**UPDATE**  
**URGENT FIELD SAFETY NOTICE**  
**MEDICAL DEVICE CORRECTION**

**MAQUET CARDIOSAVE hybrid and MAQUET CARDIOSAVE rescue**

<b>Product Code/Part Number:</b>	<b>0998-XX-0800-XX</b>
<b>Distributed Affected Lot Number:</b>	<b>All</b>
<b>Distribution Dates:</b>	<b>Since March 6, 2012</b>

**Figure 1 – Monitor Display (1 – Helium Indicator)**

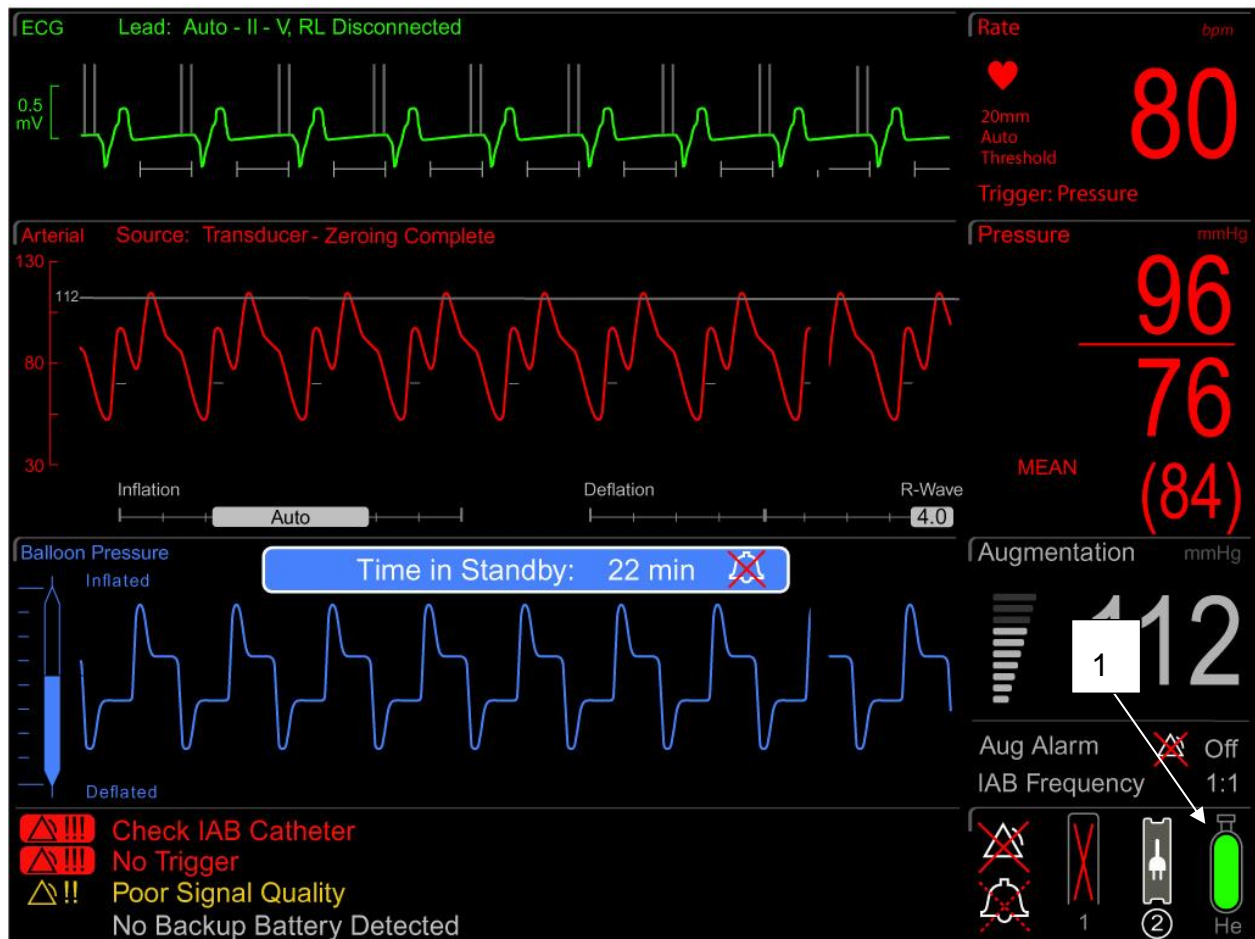
During Electromagnetic Compatibility (EMC) testing at an external lab, Getinge personnel determined that in the presence of some radiated RF disturbances, the Helium Indicator on the Cardiosave IABP (refer to Figure 1) would intermittently over-report the remaining Helium Capacity. Once the disturbance was removed the Helium indicator always fully recovered within 10 seconds to display the proper level without any over-reporting.

Getinge’s investigation revealed that the over-reporting of Helium Capacity would intermittently occur at frequency ranges between 80 MHz – 1 GHz. Potential sources of interference include: radio communication, cell phone, Wi Fi, RFID equipment and equipment that does not meet current electromagnetic compatibility standards.

Datascope/Getinge is developing a hardware correction to address this issue. A Datascope/Getinge service representative will contact you to schedule the installation of the correction when available. This work will be done at no cost to your facility.

**Figure 2 – Top Panel (1 – Mechanical Helium Gauge)**

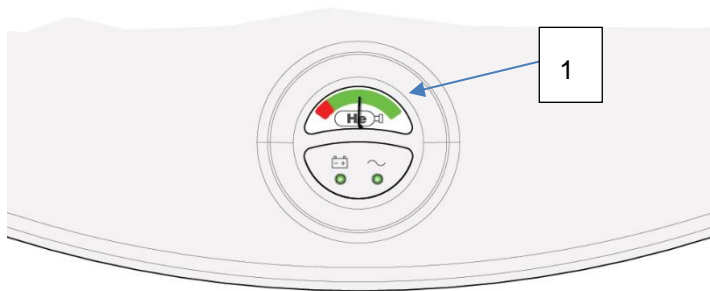
Since the mechanical gauge is not influenced by EMC, view the mechanical gauge on the Cardiosave Top Panel (See figure 2) to assess remaining helium capacity in case of suspected EMC disturbances.
